Proposed change: Excavate new ditch line to Lake Wapello.
Relocate the twin 12'x12' box culvert at Sta 400 to route FF.
Eliminate temporary pipe and flowable mortar.

END J0P0931A PROJECT
 STA 397+01 END EXCEPTION
 +06.8 RT
 TYPE II DW, 20'
 RT IN/RT OUT
 SEE SP. SH. 25

VALUE ENGINEERING CHECK SHEET

CROSS SECTIONS
 RTE 67

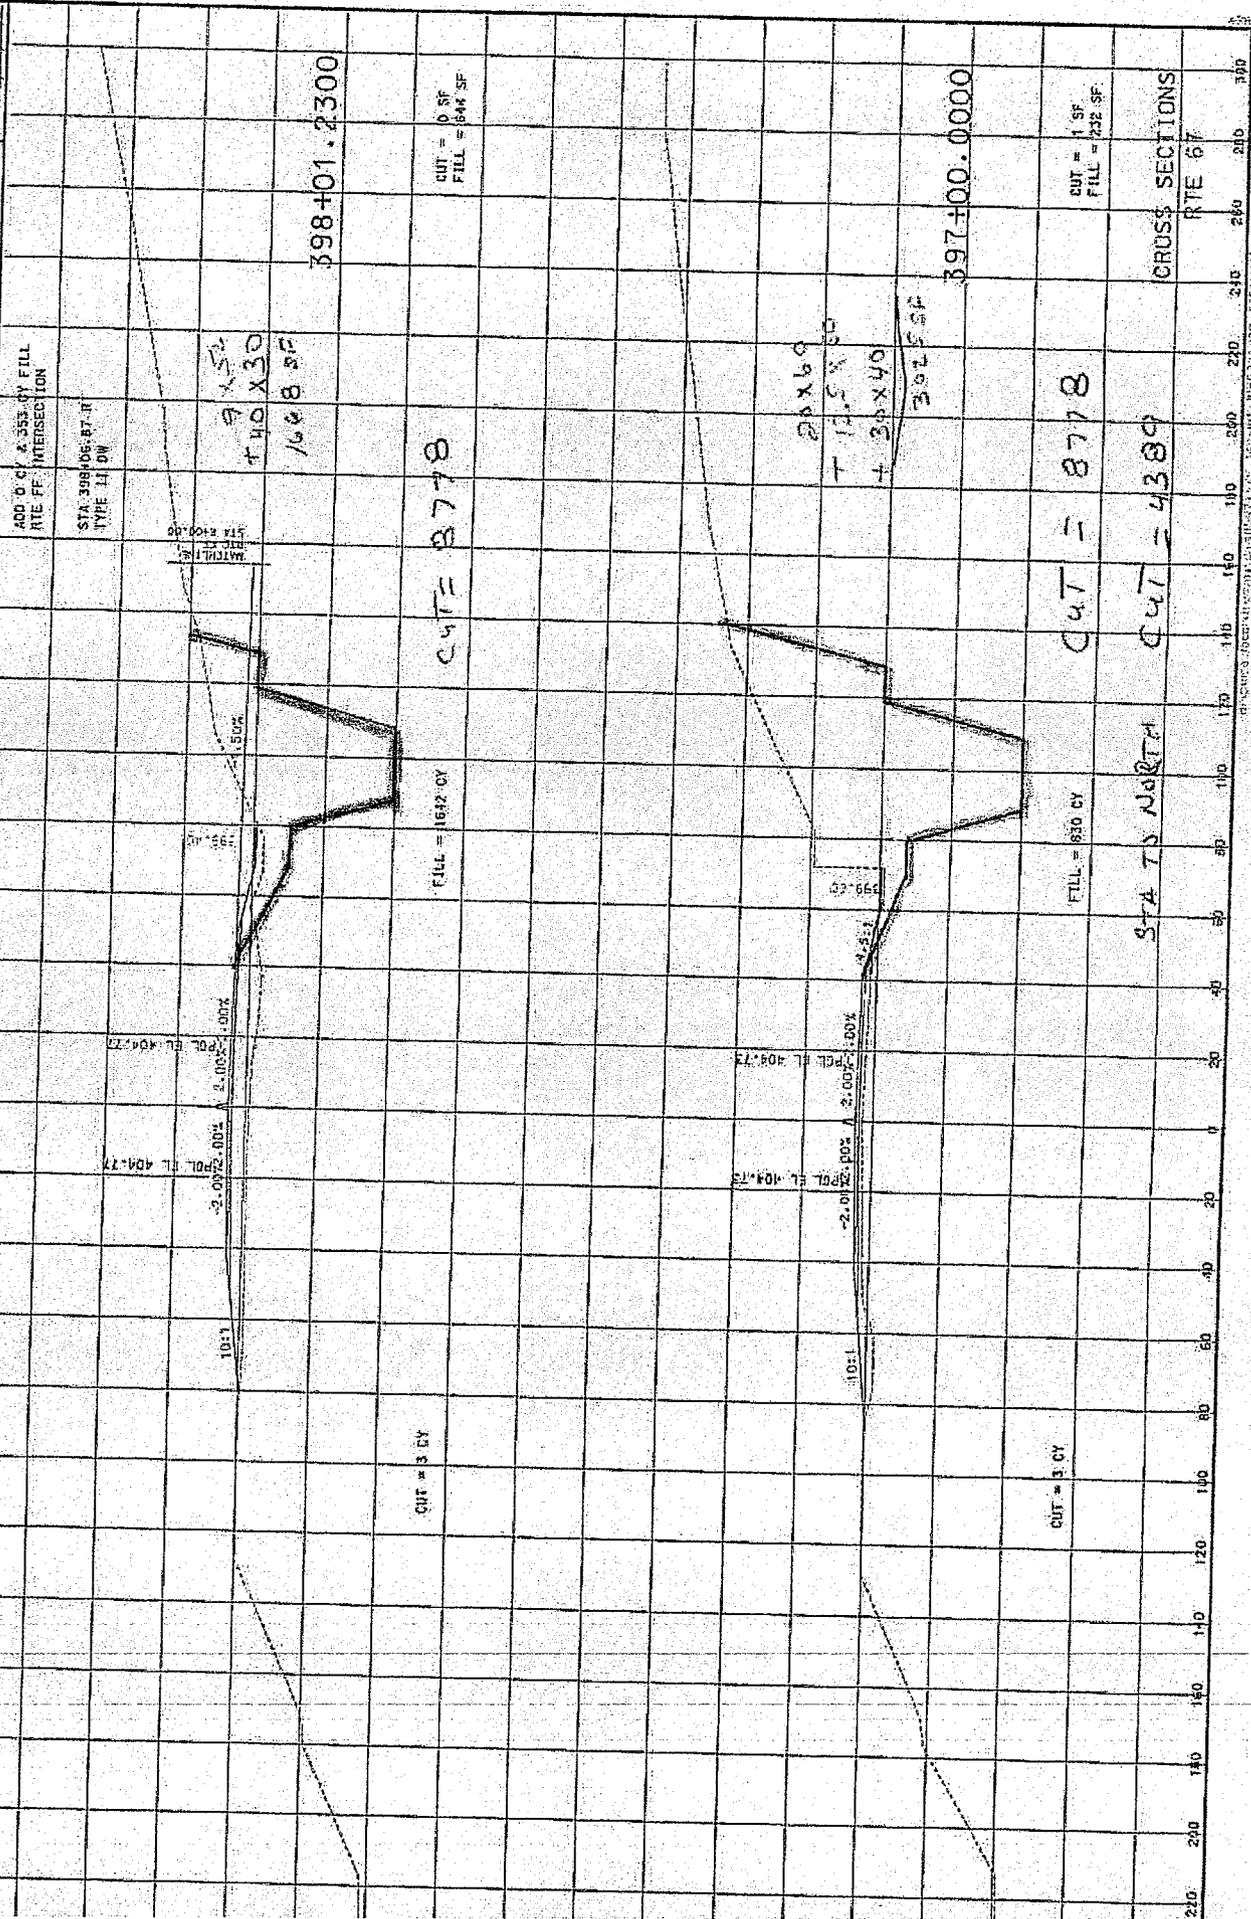
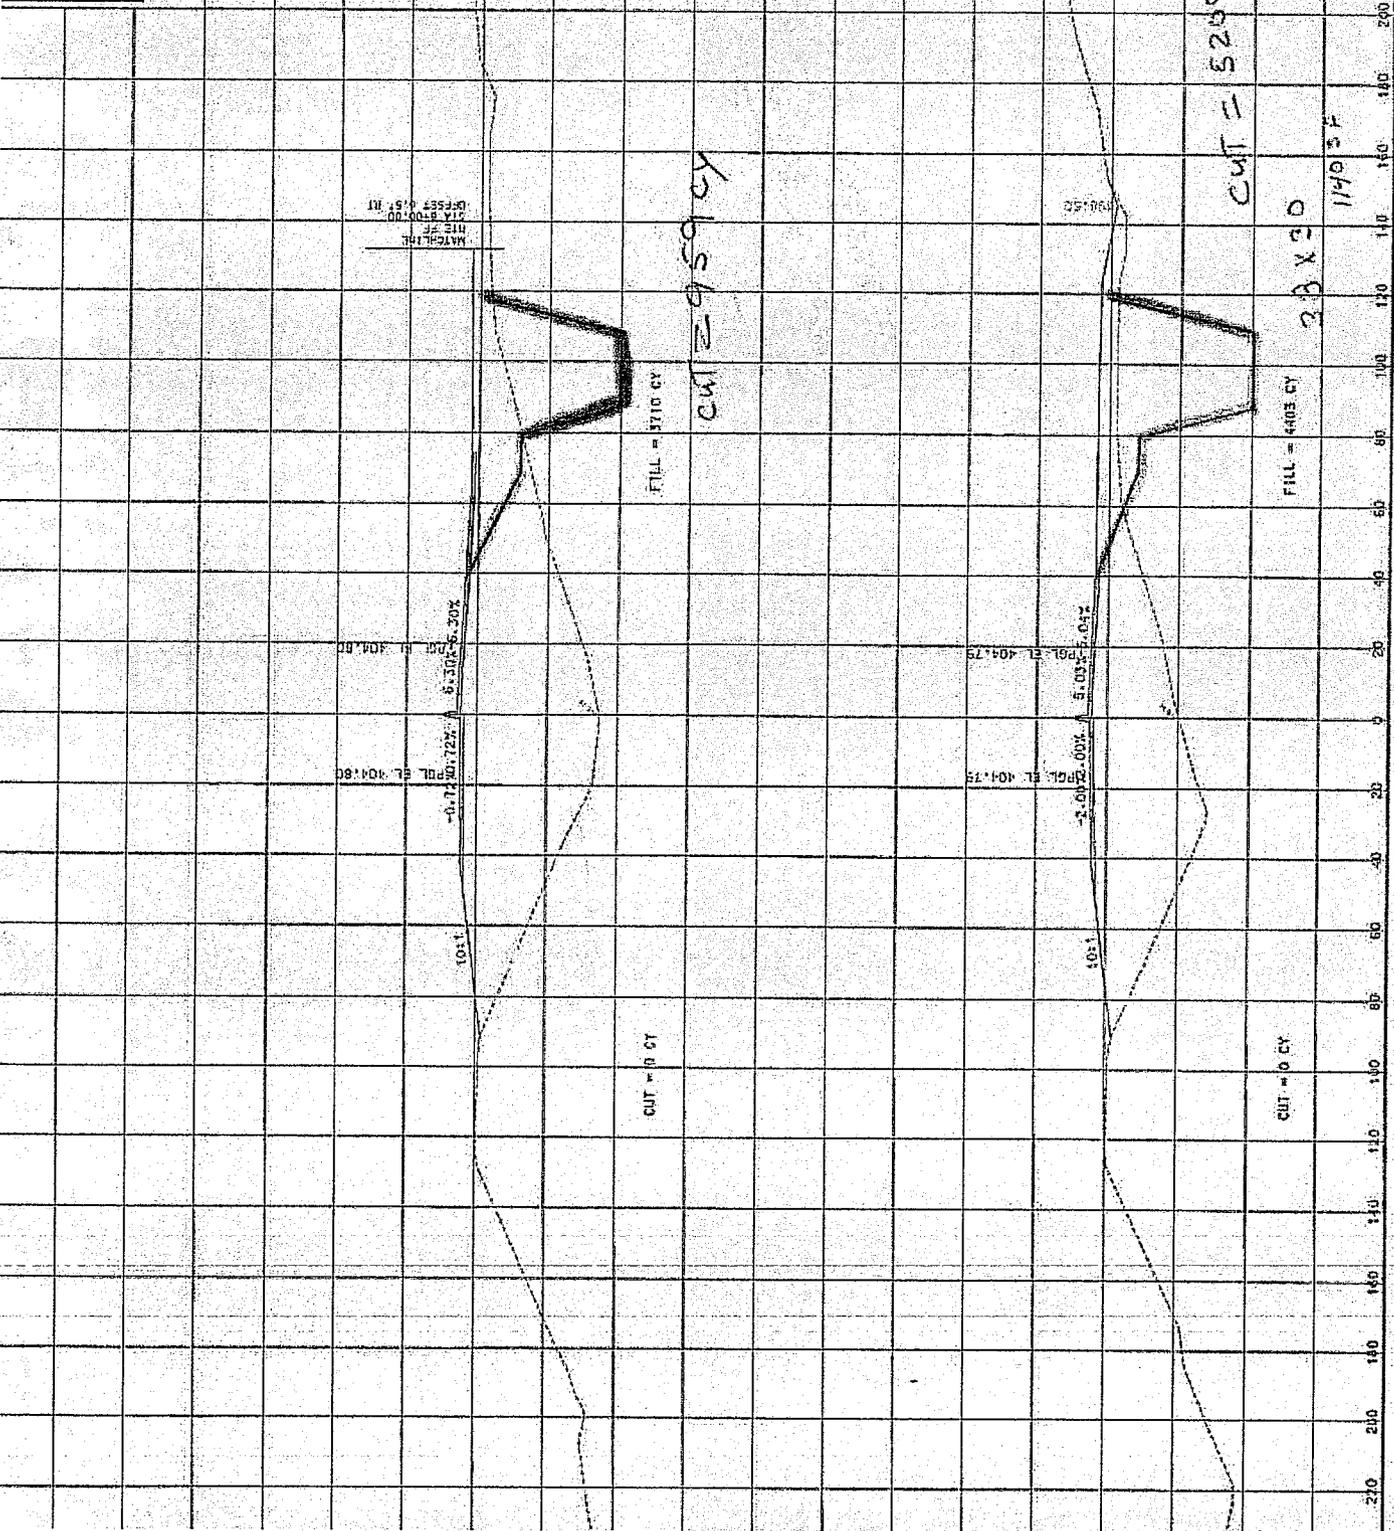
- The proposed open channel drainage incorporates ¼:1 slopes. No boring data is available to determine whether the in-situ material is of sufficient quality for this slope design. Additionally, the cross sections provided do not extend to the outlet of the proposed roadway ditch, therefore we were not able to evaluate the entire length of the channel relocation.

- The template shown on the provided cross sections do not appear to provide adequate width for guardrail. Project JOP0931A constructs a walkway across the new Wappapello Lake bridge, these plans also include an additional width of 7' 1" for a walkway/trail system. The cross sections on JOP0931 do not directly address this additional width on the pavement structure, however the in-slopes were designed such that future construction by the City of Greenville and the U. S. Army Corps of Engineers would be possible. A final proposal would have to accommodate these needs and may require a physical barrier between the walkway and proposed cut slopes.
